**PP49/2019-1**

**1 Skenes Creek Valley Road SKENES CREEK**

**Construction of Dwelling**

**SUBJECT SITE: 1 SKENES CREEK VALLEY ROAD, SKENES CREEK**  
**APPLICATION: CONSTRUCTION OF A DWELLING**

**GROUND FLOOR OVERLOOKING PLAN**  
1:200 @ A3

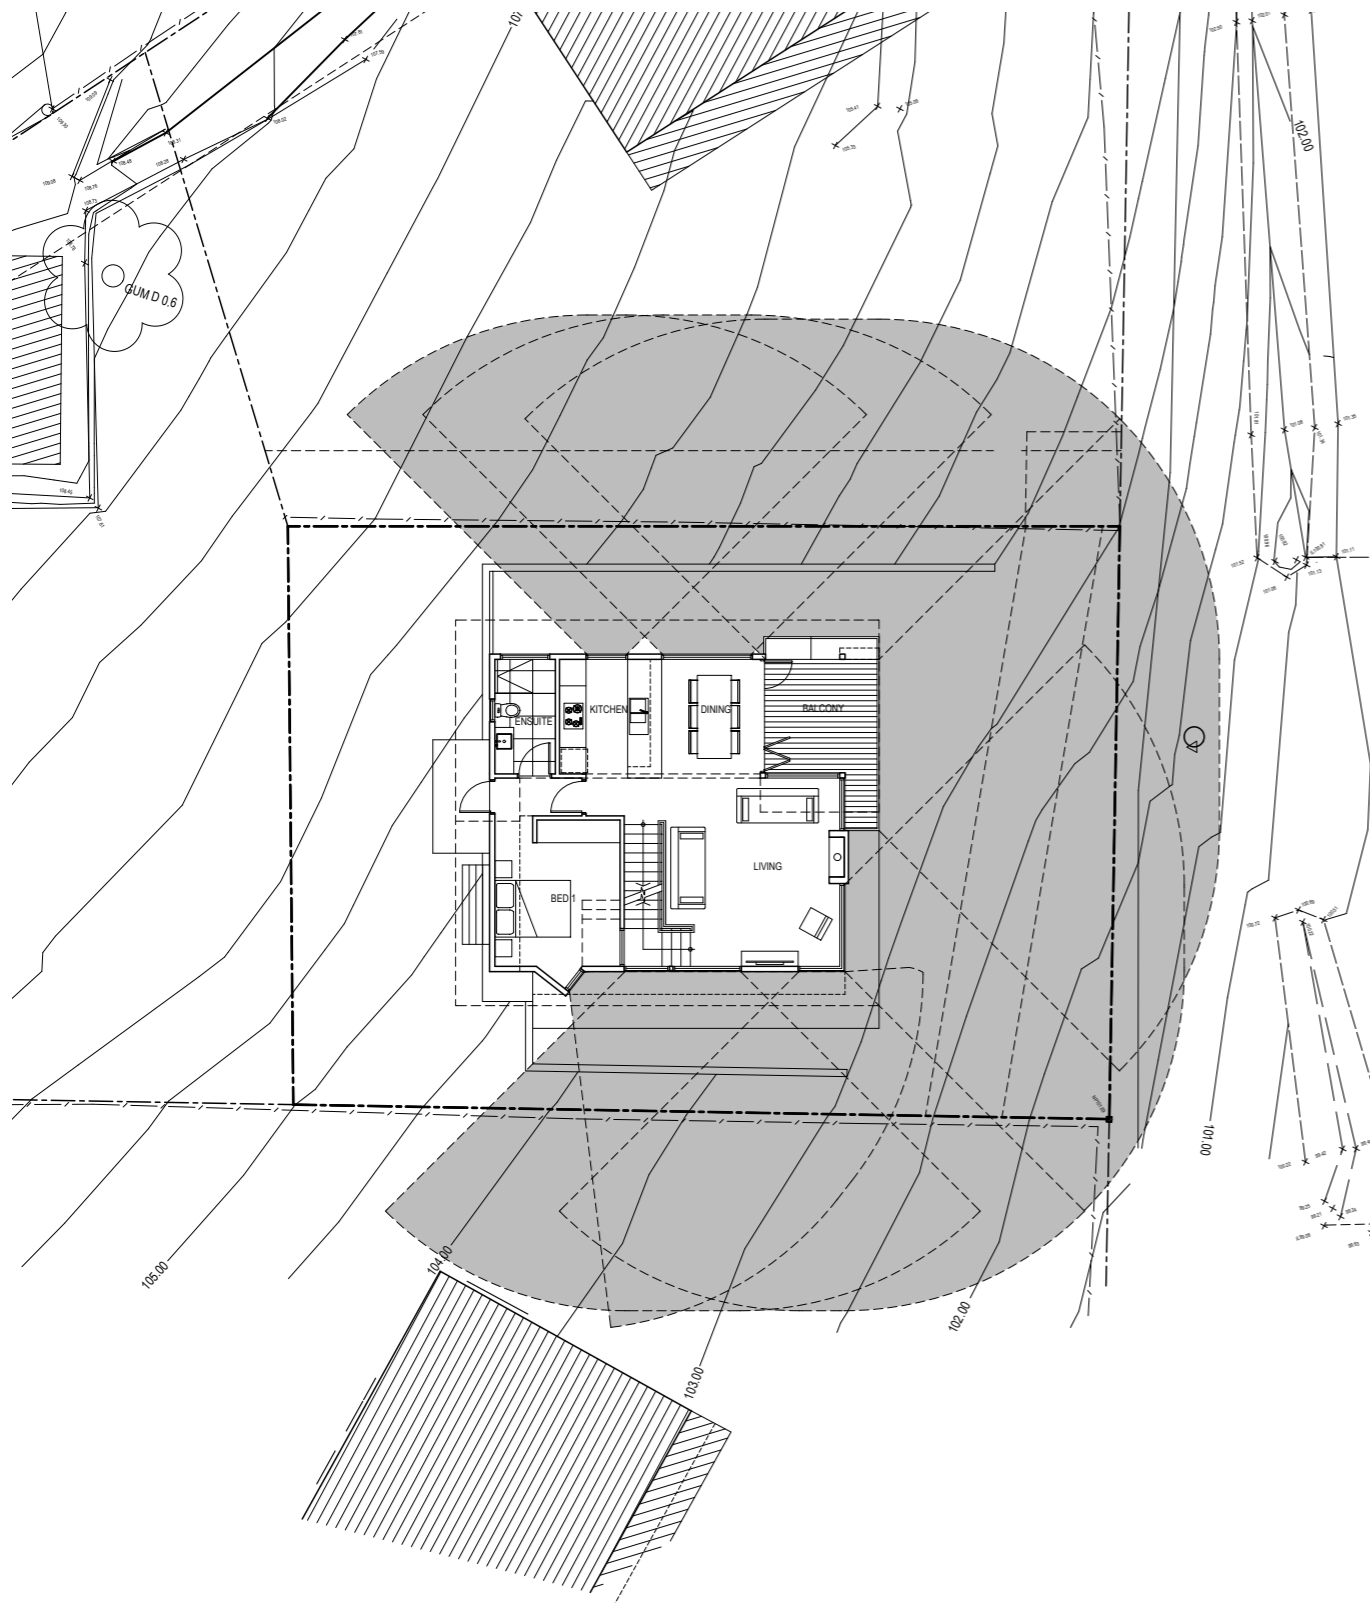
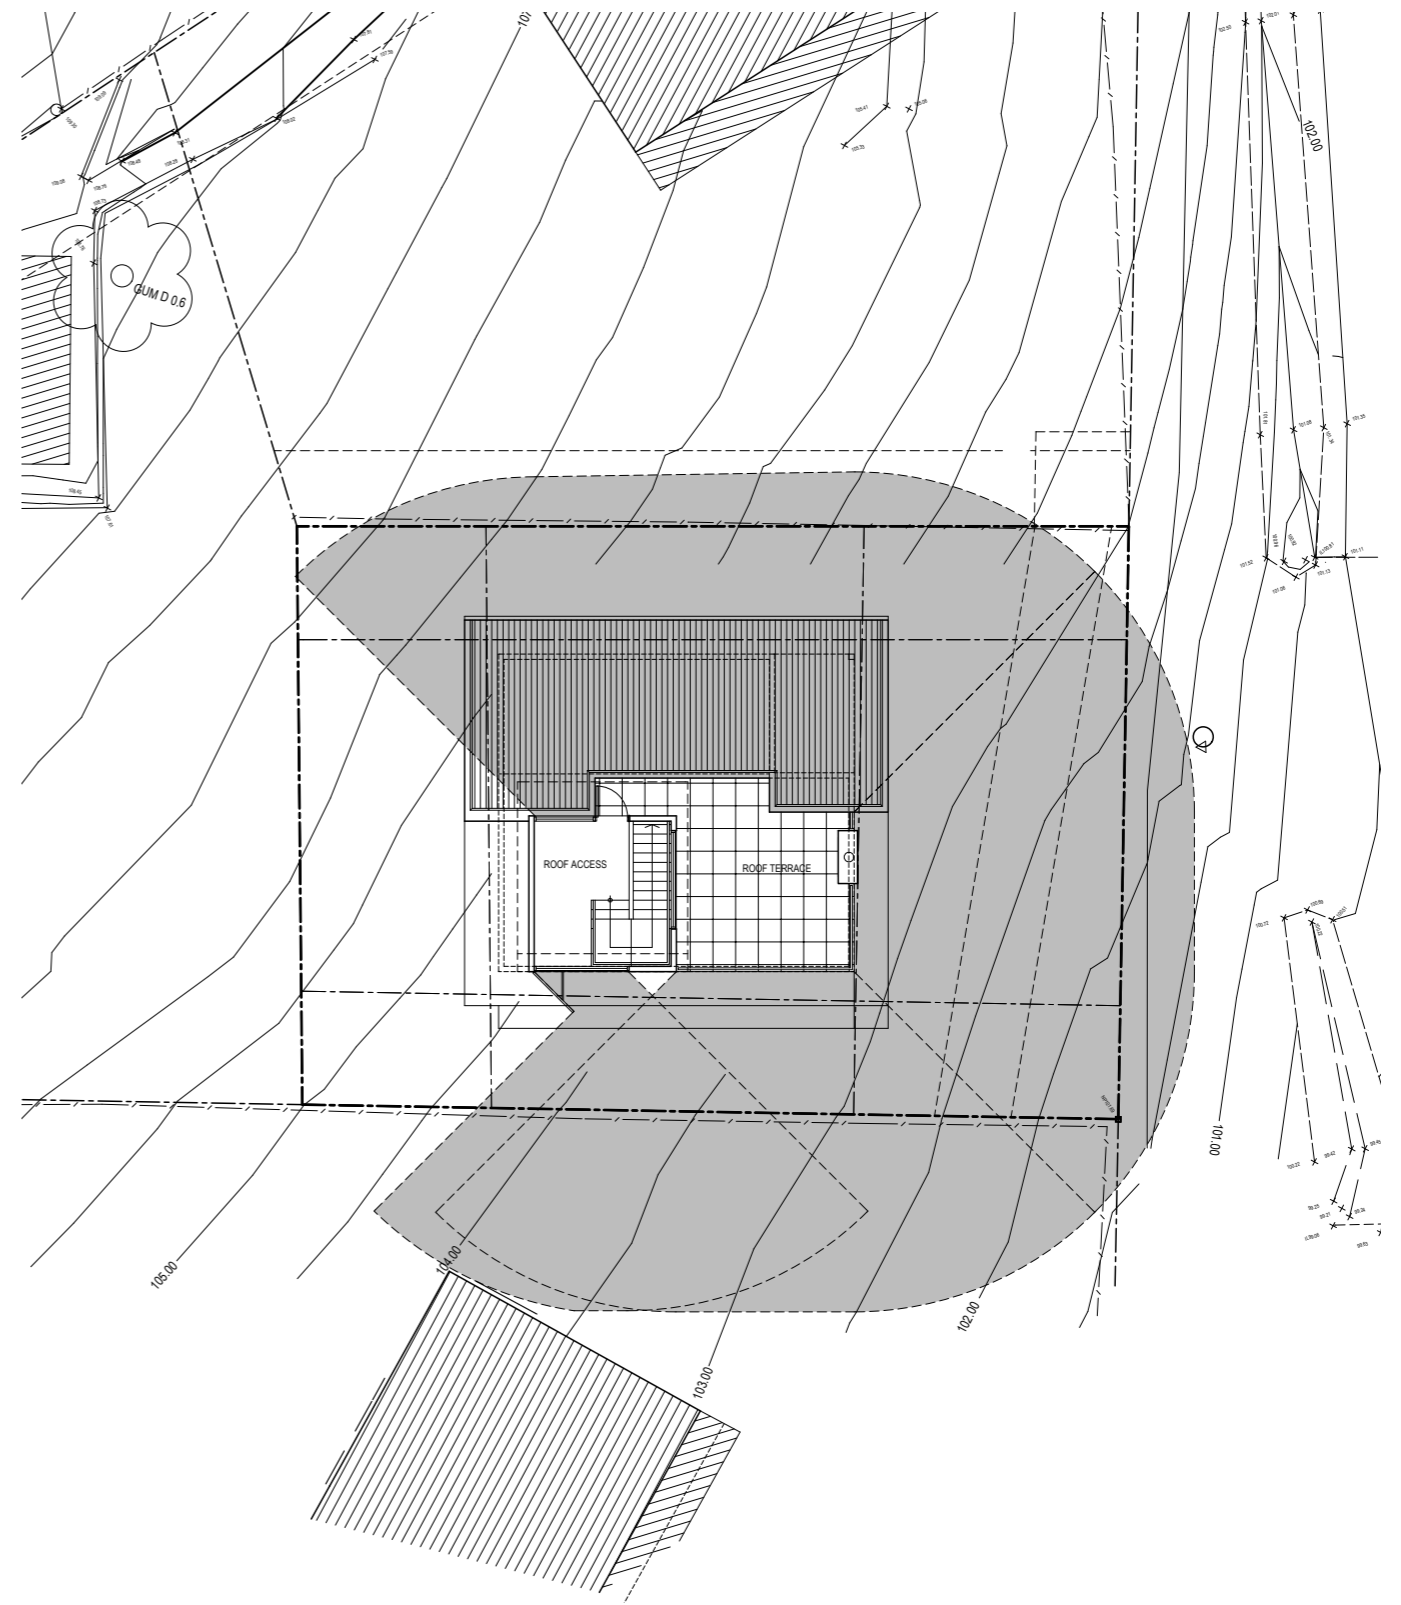
Response: Please refer to **attached** Overlooking Plan by Mark Gratwick dated February 2019. This plan shows the adjoining private open space areas/opportunities. It is noted there are no formal SPOS areas so difficult to respond directly to SPOS controls. The POS areas can be essentially anywhere on the sites as the entire urban landscape is open and informal.

Also, updated plans (12 sheets dated February 2019) **attached** show windows on south elevation TP09 to include a 2.1m high screen from the top window to assist with overlooking. The roof top viewing area is to view the ocean and coast. We seek this set of plans goes to public notice.
